Memorandum

Subject: Peer Review of “Community Choice Aggregate Feasibility Study” Draft Report dated April 6, 2017

Date: February 22, 2018

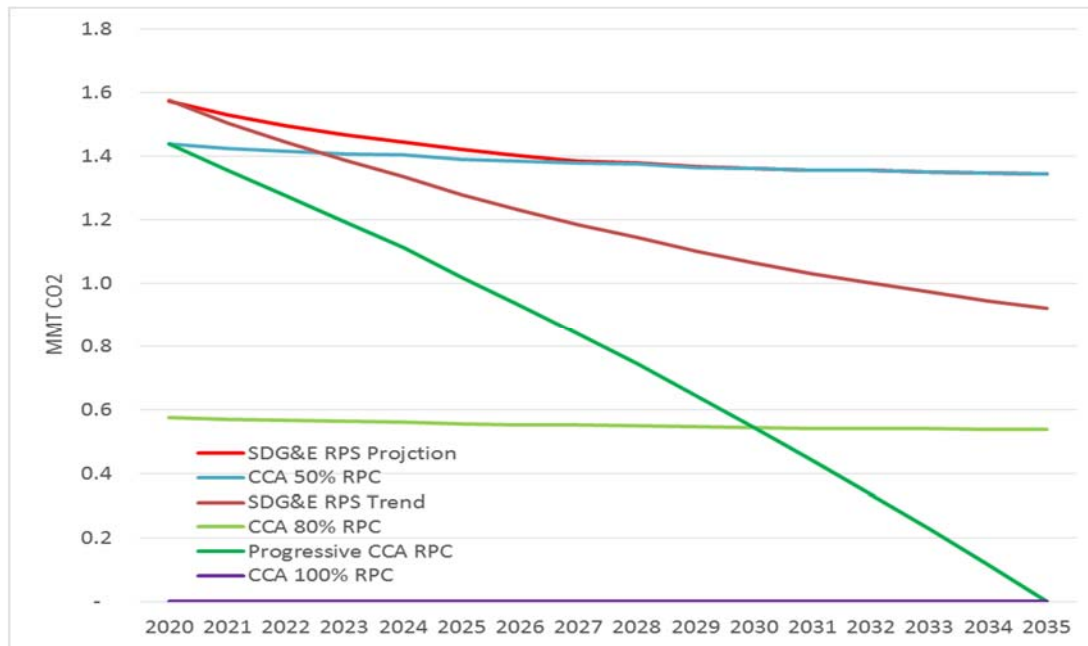
Renewable Energy Procurement. To forecast CCA renewable energy procurement costs, the Study consultants developed a best-fit logarithmic curve using average utility RPS compliance costs depicted in Figure 41 of the draft Study. The resulting RPS price forecast is likely a conservative estimate of CCA renewable energy procurement costs. This is because the data used to forecast RPS price trends do not necessarily reflect the market in which the CCA will operate since the data reflect utility procurement costs for energy delivered during a particular year. The renewable energy portfolios of utilities include contracts struck over a period of time during which technology costs have been rapidly decreasing. As a result, the decline in costs incurred by the utilities for renewable energy deliveries has lagged behind the decline in costs for new (incremental) resources. This point is referred to in footnote 60 of the draft Study, which quotes an explanation by CPUC staff. As a result, the CCA will be entering into new contracts at current and future market prices that will likely be lower than the average utility RPS compliance cost as reflected in Figure 41. The Monte Carlo Simulation Model (MCSM) used for the Study is useful for reflecting uncertainty in forecasts of procurement costs, by providing a statistically characterized range around this base forecast. The report does not provide information concerning the way in which RPS price uncertainty was characterized in the MCSM, so it is not possible to review the reasonableness of these assumptions.
